STAFF REPORT
COMMUNITY DEVELOPMENT DEPARTMENT

HEARING DATE: 2/3/2022
 TO: Planning & Zoning Commission
 FROM: Alan Tiefenbach
 208-884-5533
 SUBJECT: AZ, PP - H-2021-0088
 Quartet South Subdivision
 LOCATION: Parcels S0434255555, S0434325410,
 S0434325867 and 3680 N. Black Cat
 Rd., located at the northeast corner of the
 N. Black Cat / W. Ustick Rd intersection.

Annexation of 67.61 acres of land with the R-8 and R-15 zoning district, and preliminary plat consisting of 229 building lots, future townhome or multifamily units, and 42 common lots.

B. Preliminary Plat (date: 1/25/2022)

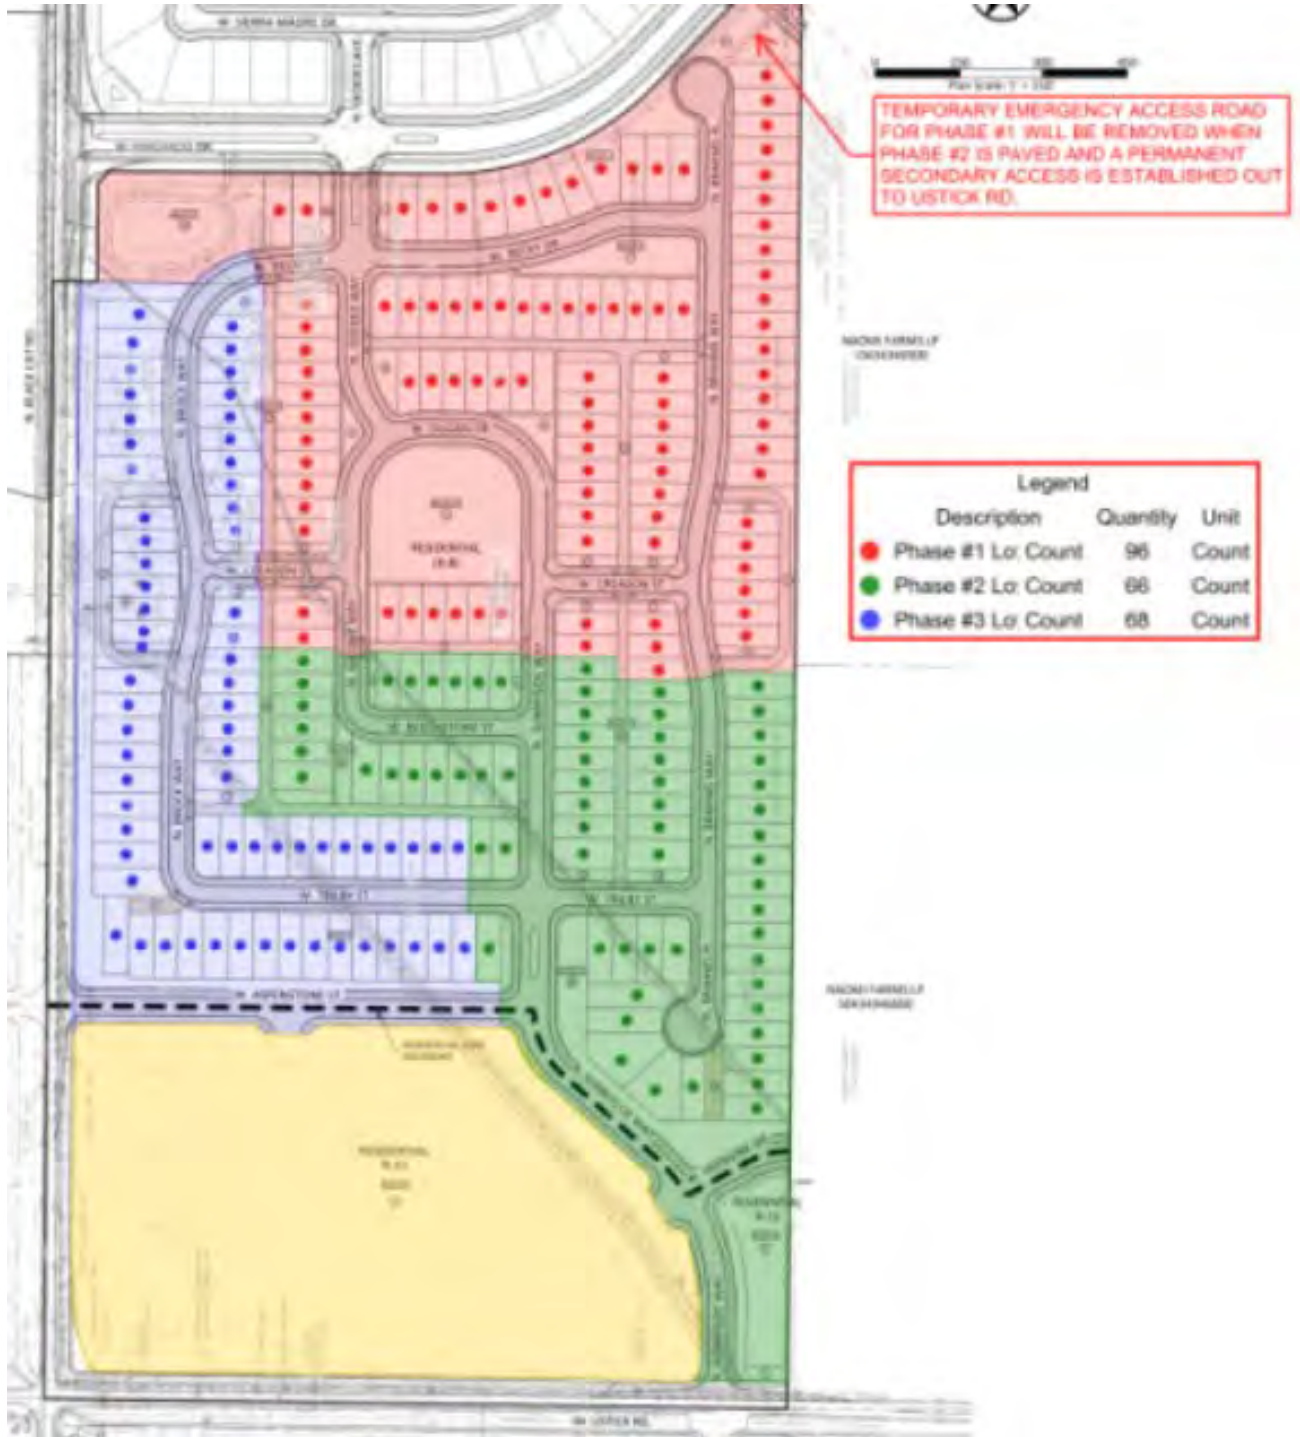
UDC 11-6C-3-B-5 states “alleys shall be designed so that the entire length is visible from a public street.” The plat reflects alleys that are aligned north – south and intersect with another alley in a “t-intersection” that does not allow visibility of the entire alley from a public street. UDC 11-5B-5 does not allow alternative compliance from this requirement. The plat must be revised accordingly, such as extending these alleys.

increase in block length to 1,000 feet if a pedestrian connection is provided. Staff has reviewed the submitted plat for conformance with these regulations. It does appear this limit is exceeded along the eastern boundary of the property. The applicant should revise the plat to meet the requirements of UDC 11-6C-3.

It does appear that the project meets the minimum open space requirements, although there are portions of Lot 13 of Block 2, Lot 7 and 43 of Block 6, and Lot 6 of Block 9 that do not meet the minimum required 20 ft. width to be credited as open space. The open space exhibit should be revised accordingly.

2. The Preliminary Plat included in Section VI, dated 7/15/2021, is approved with the following revisions:
 - a. The plat should be revised to provide a transition between the east property line and the adjacent property to the east. Staff recommends a north – south road along the eastern property line.

- b. All alleys shall meet the requirements of UDC 11-6C-3 that requires the entire length to be visible from a public street.
 - c. All pathways and micropath shall be within a separate common lot or easement as required per UDC 11-3A-8.

3. The landscape plan and open space exhibit shall be revised to match the Preliminary Plat, dated 7/15/2021.
4. Prior to City Council, the open space exhibit shall be revised to remove any areas of less than 20 ft. in width from being credited as qualified open space.
